# Next steps for EEE Draft

Sanjay Kasturia  
Editor-in-chief 802.3az  
Energy Efficient Ethernet  
[skasturia@teranetics.com](mailto:skasturia@teranetics.com)  
(650) 704-7686

# Status

# Comment statistics (Tech)

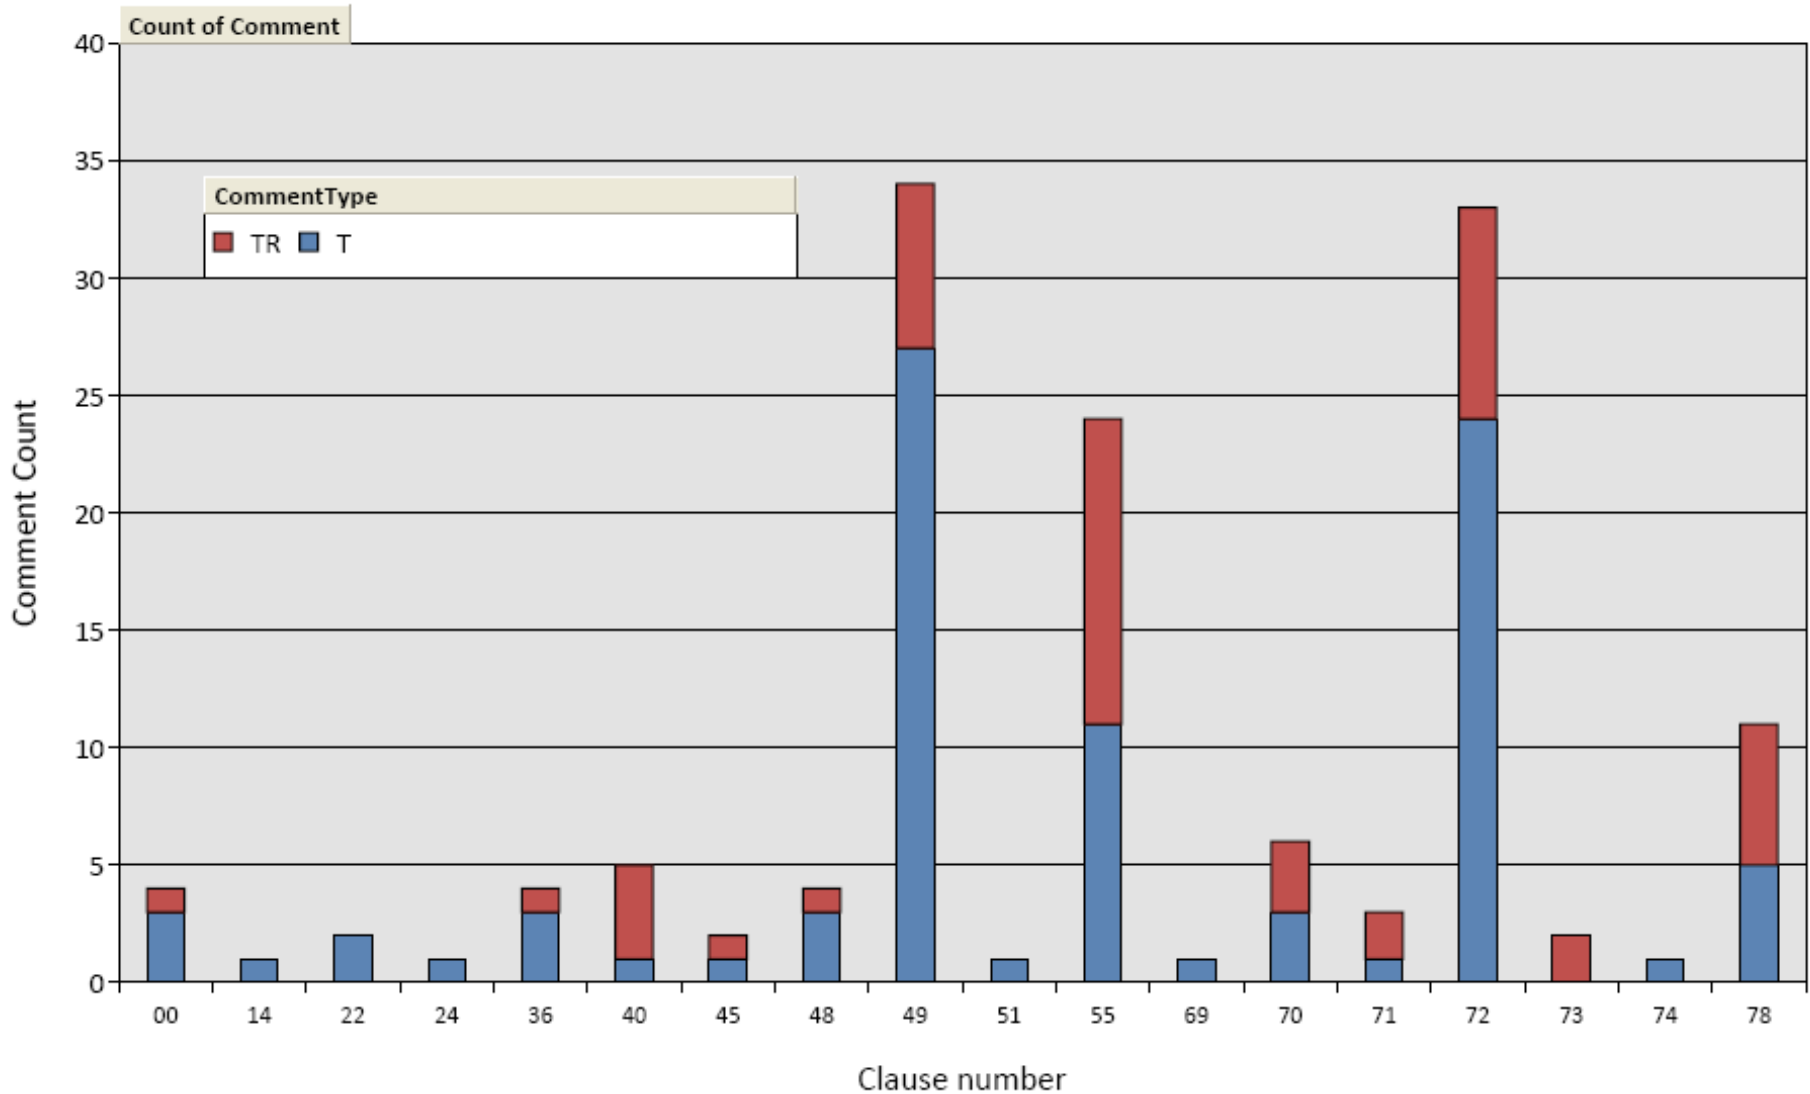
- D1.2.1 was published in February
  - Backplane saw significant changes
  - Discussion on LLDP and shrinkage led to the formation of two Ad Hoc – reports available
- We received a large number of comments
  - ~210 total, 139 technical
  - Among BASE-Ts, 55 has the largest number
  - Large percentage on backplane and Clause 78
  - See next slide for stats
